NORTHEAST UTILITIES

Millstone Nuclear Power Station, Unit No. 3
Submittal of Revised Responses to PSB Electrical Draft SER Items

Millstone Nuclear Power Station, Unit No. 3

Open Items

Sheet 1 of 4
Fig. 8.3-8

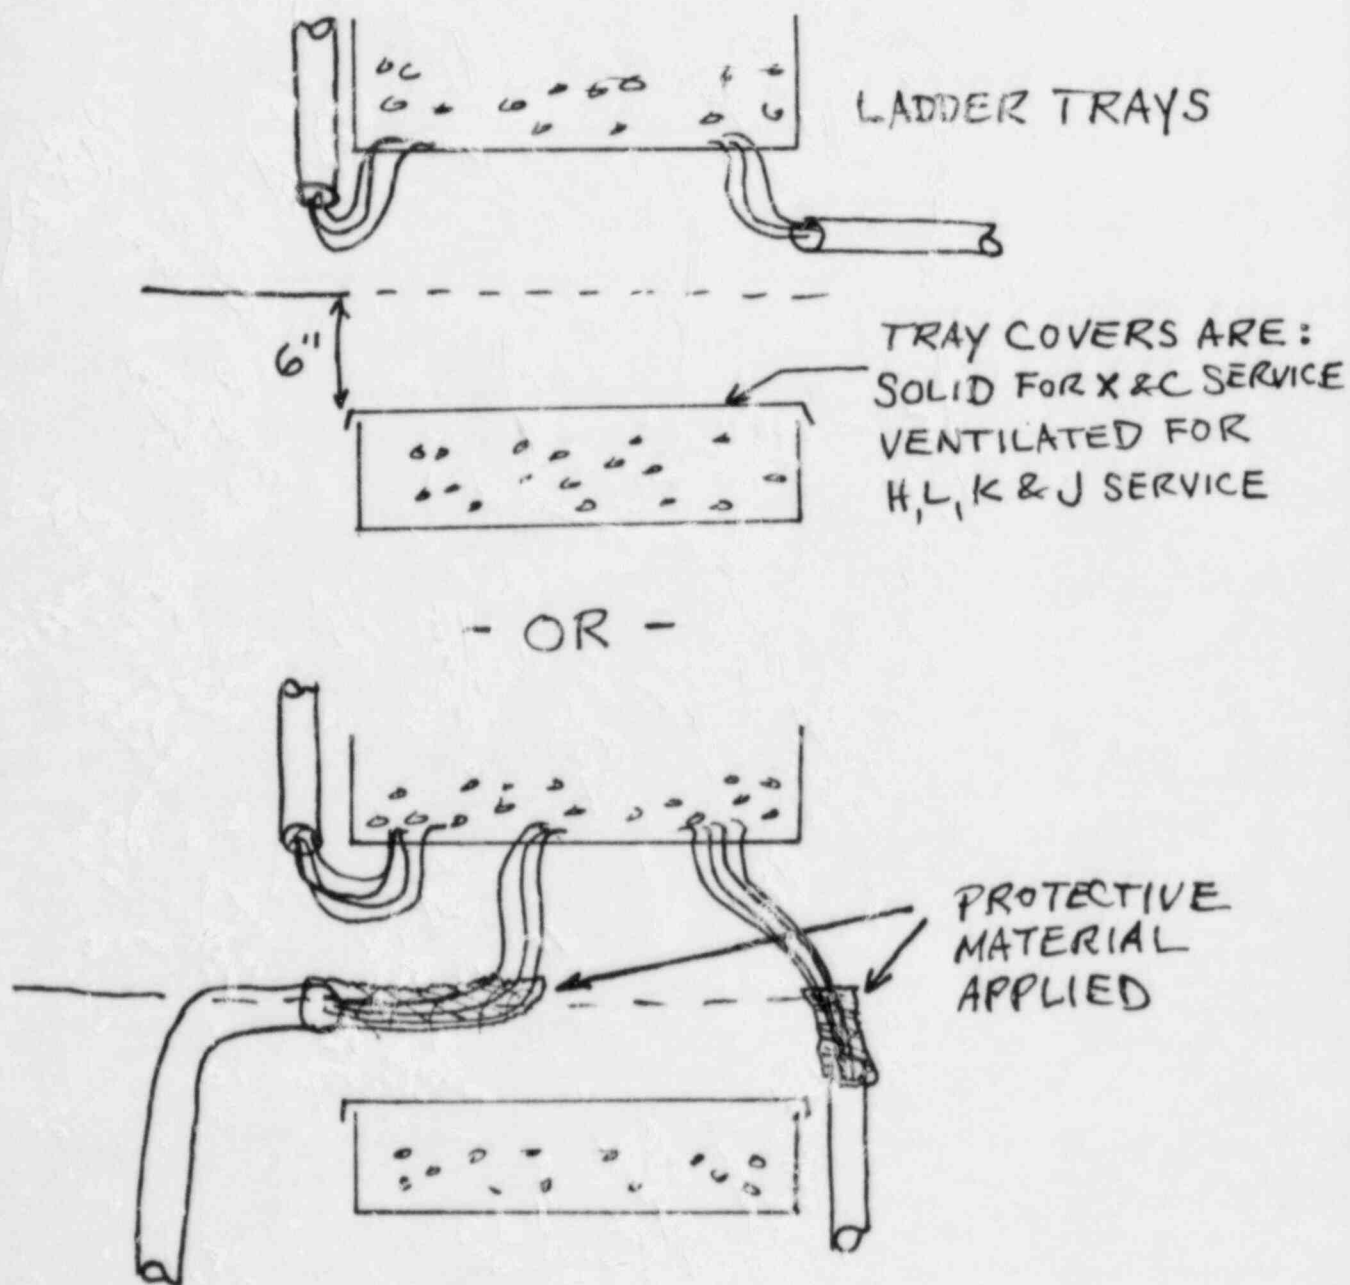
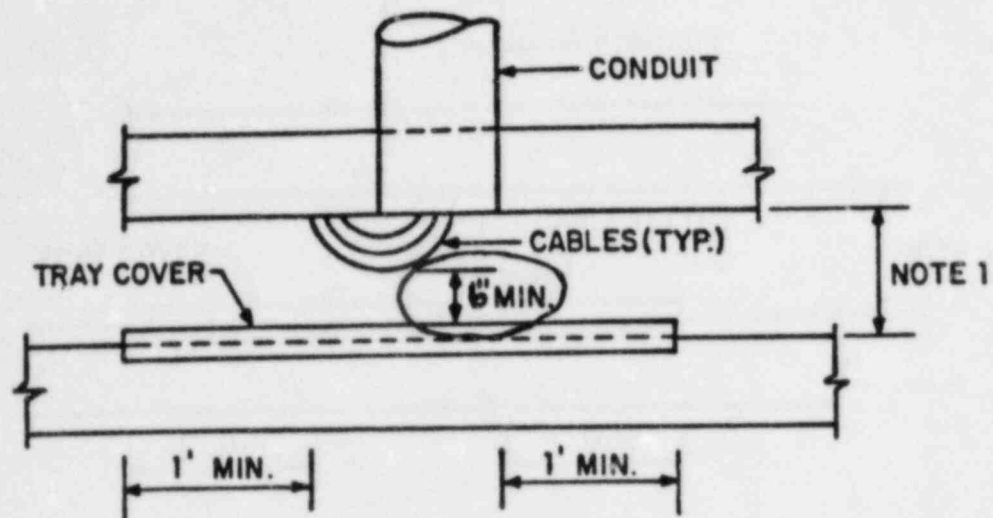
In Section 1.8 of amendment 3 of the FSAR, the applicant has indicated with respect to clarification of the guidelines of Regulatory Guide 1.75, that separation at cable entry/exit from cable trays is equivalent to perpendicular cable tray crossing. Further clarification of the separation will be pursued with the applicant and the results will be reported in a supplement to this report.

Refer to revised section 1.8, R. G. 1.75 and new Figure 8.3-8.

BARE CABLES EXITING A CABLE TRAY SHALL REMAIN SIX (6) INCHES OR GREATER ABOVE A COVERED CABLE TRAY BELOW.

A PROTECTIVE MATERIAL SHALL BE APPLIED TO THAT PORTION OF A CABLE DROPOUT WHICH IS LESS THAN SIX (6) INCHES ABOVE THE TRAY COVER.
